APPLICATION NO.	FILING DATE	FIRST NAMED INVENTOR	ATTORNEY DOCKET NO.	CONFIRMATION NO.
09/619,479	07/19/2000	Shunpei Yamazaki	0756-2188	1883
7590	03/29/2004			
Robinson Intellectual Property Law Office PMB 955 21010 Southbank Stret Potomac Falls, VA 20165			EXAMINER RUDE, TIMOTHY L	
			ART UNIT 2871	PAPER NUMBER

Office Action Summary

DETAILED ACTION

FIG. 4A

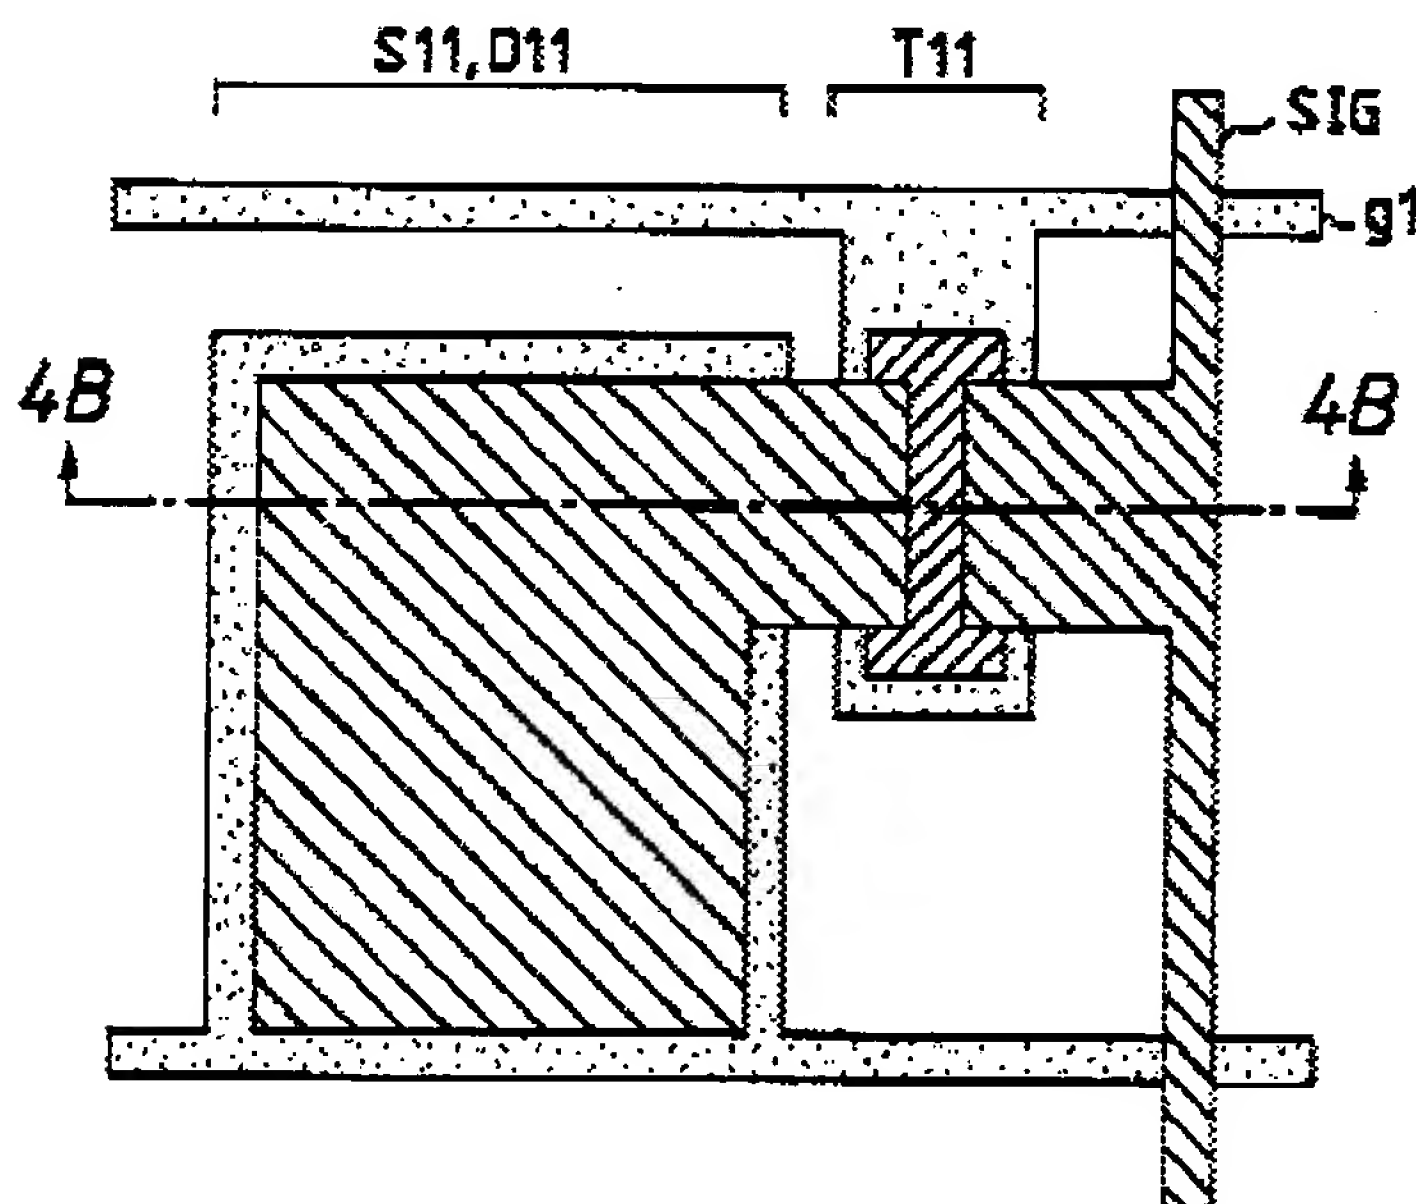
As to claims 1, 23, 25, and 29, Kaifu discloses an embodiment (col. 14, line 53 through col. 17, line 13) that is explained in part by Figures 3, 4A, and 4B, (col. 5, line 26 through col. 14, line 52) wherein an integral image recognition/display apparatus comprises: a plurality of pixel portions, D11, each having an active device, T11, and arranged in matrix and each having a pixel electrode (left portion in Figure 4B), comprising 10,000 angstrom thick layer of aluminum (Applicant's a reflecting material), 6, and n-doped silicon (Applicant's light-transmitting material), 5, (Applicant's pixel electrode comprises a first layer and a second layer, said second layer provided over

said first layer, one of said first layer and said second layer comprising a reflecting material (10,000 angstrom thick layer of aluminum) and the other comprising light-transmitting material (n-doped silicon)) over an active matrix substrate, 1; and a plurality of sensor portions, S11, arranged in matrix over said active matrix substrate, wherein said sensor portion includes a photo-electric conversion device, 4, and can read information by utilizing the rays of light transmitting through said light-transmitting material when an external image is read (Abstract), wherein said photo-electric conversion device, 4, overlaps the TFT (Applicant's active device).

Note: the removal (col. 7, lines 12-22) of a portion of the aluminum electrode, 6, is not shown in Figures 4A and 4B. However, an illustration may be found in Figures 11A and 11B (Applicant's wherein a plane parallel to a direction of said matrix is divided into at least a first display region and a second display region in said pixel electrode, wherein said pixel electrode comprises a reflecting material, 6, in said first display region, and wherein said pixel electrode comprises a light-transmitting material, 5, in said second display region) (col. 14, line 53 through col. 17, line 13),

As to claim 2, Kaifu discloses in Figure 4B the apparatus according to claim 1, wherein said active device comprises a bottom gate type TFT, T11.

As to claim 8, Kaifu discloses in Figures 3, 4A, and 4B, an integral image recognition/display apparatus comprising: a plurality of pixel portions, D11, each having an active device, T11, and arranged in matrix and each having a pixel electrode, (left portion in Figure 4B), comprising a reflecting material, 6, and a light-transmitting material, 5, over an active matrix substrate, 1; and a plurality of sensor portions, S11, arranged in matrix over said active matrix substrate, wherein said sensor portion has a photo-electric conversion device, 4, and at least a part of said photo-electric conversion device, 4, is extended in such a manner as to overlap with said active device, T11, wherein said pixel electrode, 6, has an image display function (col. 11, line 66 through col. 12, line 10; see also incident light ray L2 and reflected light ray L3 in Figure 4B).

As to claim 12, Kaifu discloses in Figures 3, 4A, and 4B, a semiconductor device comprising: a pixel portion, D11, having an active device, T11, and a pixel electrode comprising a reflecting material, 6, and a light-transmitting material, 5, over an active

matrix substrate; and a sensor portion, S11, provided over said active matrix substrate, 1; and comprising a photo-electric conversion device, 4, wherein said active device and said pixel electrode and said photo-electric conversion device are provided in one of pixels arranged in matrix, and wherein said sensor portion can read information by utilizing the rays of light transmitting through said light-transmitting material when an external image is read (Abstract), wherein said pixel electrode, 6, has an image display function (col. 11, line 66 through col. 12, line 10; see also incident light ray L2 and reflected light ray L3 in Figure 4B).

FIG. 11A

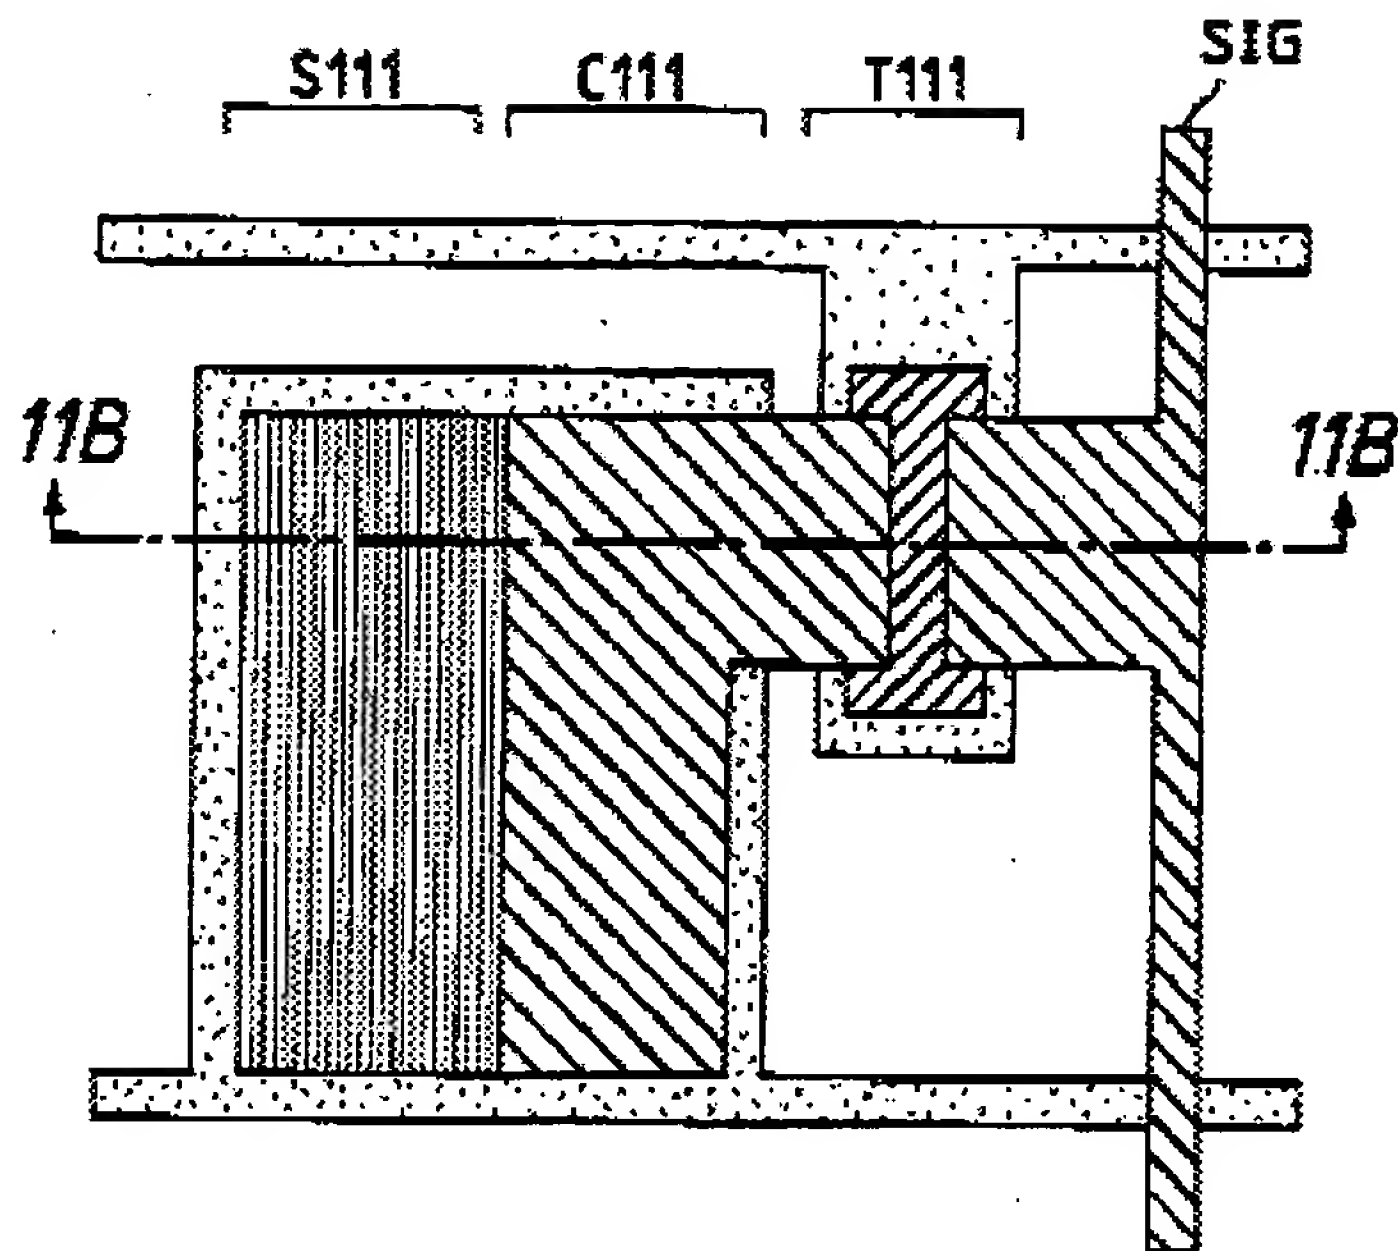
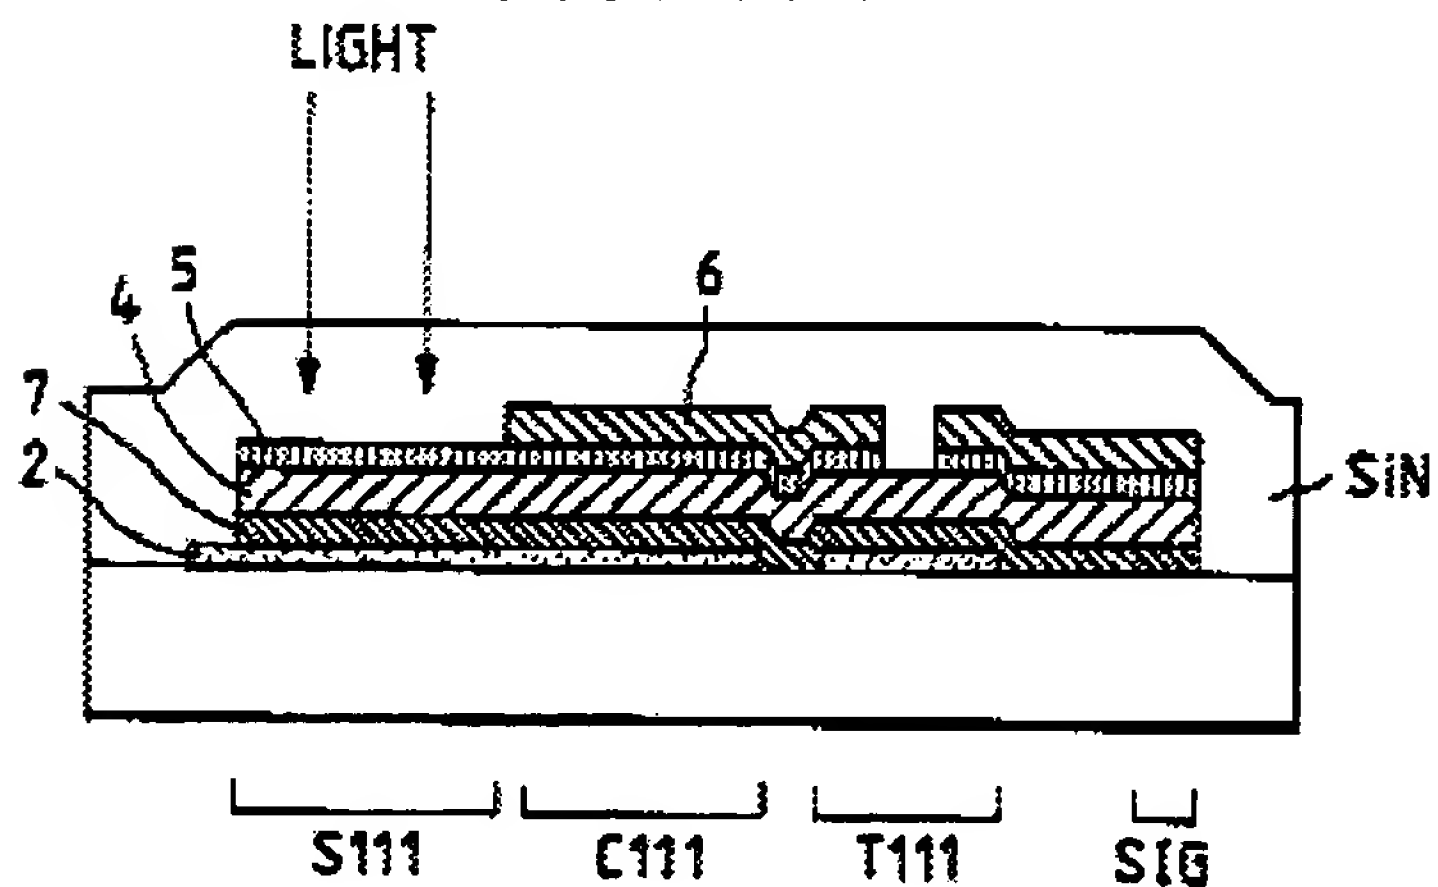
wherein said pixel electrode, 6, has an image display function (col. 11, line 66 through col. 12, line 10; see also incident light ray L2 and reflected light ray L3 in Figure 4B).

Please note: the difference between the embodiment of Figure 11B and that of Figures 4B is 11B performs the image input and display on the top side as opposed to 4B

performing the image input on the bottom side and the image display on the top side.

Please also note: in Figure 11B pixel electrode, 6, is energized for image display which also necessarily energizes transparent n-type silicon structure, 5, that functions as a transparent pixel electrode in the display mode.

It is respectfully pointed out that Kaifu discloses the removal (col. 7, lines 12-22) of a portion of the reflective aluminum electrode, 6, as may be found in Figures 11A and 11B (Applicant's wherein a plane parallel to a direction of said matrix is divided into at

least a first display region and a second display region in said pixel electrode, wherein said pixel electrode comprises a reflecting material, 6, in said first display region, and wherein said pixel electrode comprises a light-transmitting material, 5, in said second display region). Please note: said pixel electrode, 6, has an image display function (col. 11, line 66 through col. 12, line 10; see also incident light ray L2 and reflected light ray L3 in Figure 4B). The difference between the embodiment of Figure 11B and that of Figures 4B is 11B performs the image input and display on the top side as opposed to 4B performing the image input on the bottom side and the image display on the top side. Please also note: 11B energizes pixel electrode, 6, for image display which also necessarily energizes transparent n-type silicon structure, 5, that functions as a transparent pixel electrode in the display mode.

FIG. 1

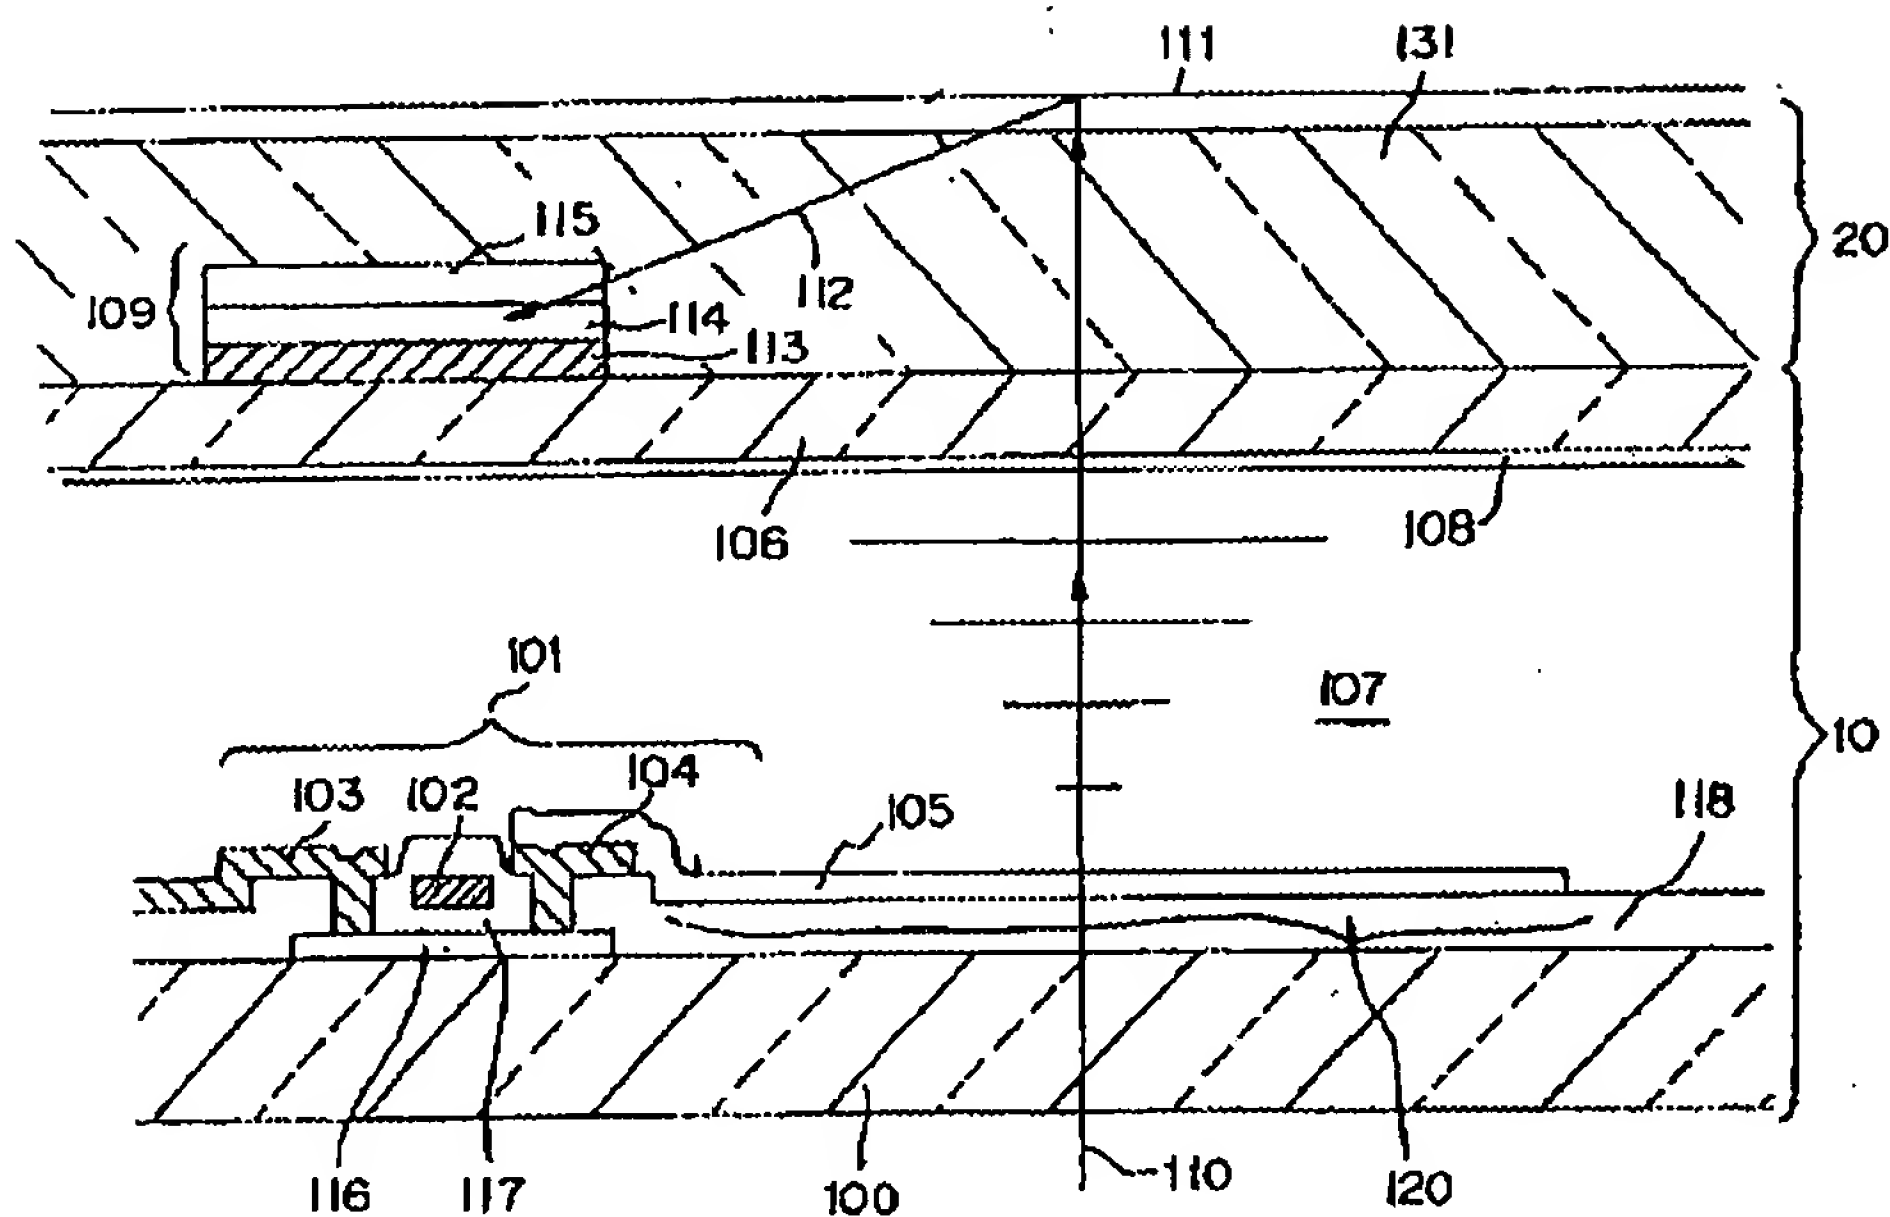
Itoh teaches the use of a top gate TFT, 101, in an integral image recognition/display apparatus in Figure 1 as an art recognized means suitable for the intended purpose of comprising a TFT for improved switching (turning on and off) of the pixel electrodes (MPEP 2144.07) (col. 5, lines 3-11).

Itoh is evidence that ordinary workers in the art of liquid crystals would find the reason, suggestion, or motivation to add top gate TFTs as an art recognized means suitable for the intended purpose of comprising a TFT for improved switching of the pixel electrodes (col. 5, lines 3-11).

Therefore, it would have been obvious to one having ordinary skill in the art of liquid crystals at the time the invention was made to modify the integral image recognition/display apparatus of Kaifu with the top gate TFTs of Itoh as an alternate means providing design and manufacturing flexibility for improved switching of the pixel electrodes.

Itoh teaches in Figure 1 the use of a plurality of sensor portions, 109, disposed in matrix over an opposed substrate, 106, constituting a display panel, wherein said sensor portion has a photo-electric conversion device (col. 4, lines 36-42), and can read information by utilizing the rays of light, 110, transmitting through said light-transmitting material when an external image, 111, is read.

Itoh is evidence that ordinary workers in the art of liquid crystals would find the reason, suggestion, or motivation to add photo-electric conversion devices to the opposed substrate to improve contrast (col. 4, lines 56-60).

Therefore, it would have been obvious to one having ordinary skill in the art of liquid crystals at the time the invention was made to modify the integral image recognition/display apparatus of Kaifu with photo-electric conversion devices on the opposed substrate of Itoh to improve contrast for superior image display.

Itoh teaches in Figure 1 the use of a plurality of sensor portions, 109, disposed in matrix over an opposed substrate, 106, constituting a display panel, wherein said sensor portion has a photo-electric conversion device (col. 4, lines 36-42), and can read information by utilizing the rays of light, 110, transmitting through said light-transmitting material when an external image, 111, is read.
